REMARKS

Responsive to the Final Official Action dated February 28, 2006, the claims are now amended differently from the amendments proposed previously.

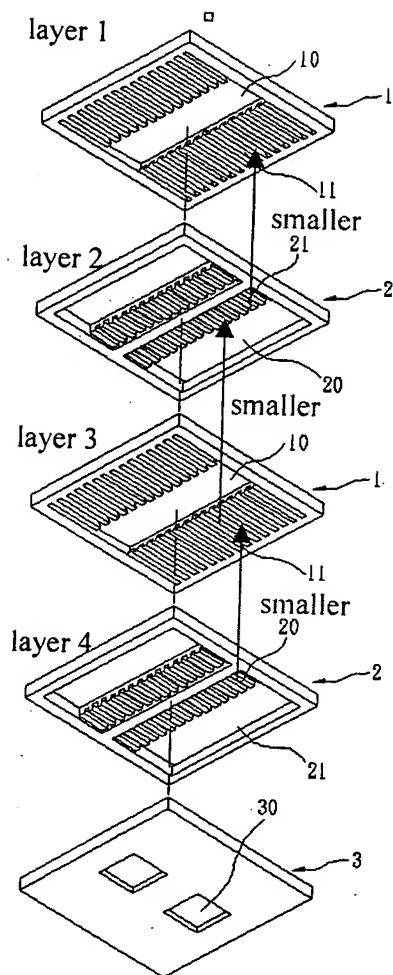
Proposed Drawing Change. A replacement Fig. 5 is submitted to correct a drafting error. The old Fig. 5 showed incorrect orientations of the structures 1 relative to the structures 2 and 3; in Fig. 5, the structures 1 are rotated by 90 degrees around a vertical axis, so that if the structures shown in Fig. 5 had been compressed together while retaining their incorrectly-illustrated rotational orientations, the resulting sandwich would conflict with original claim 1 (reciting "a plurality of through channel structures [2] respectively connected to the filtering channel structures [1], wherein each defines a second through hole [20] *connected to* [aligned with] the first concave portion [11]") and also with Figs. 6 and 9. The correct orientations of the structures 1 are shown in Fig. 4.

The proposed drawing change does not conflict with the original disclosure, because the original disclosure did specify the rotational orientations of the Fig. 5 structures.

The Examiner is invited to consider that sandwich resulting from collapse of Fig. 5 would not filter anything, contrary to the rest of the disclosure.
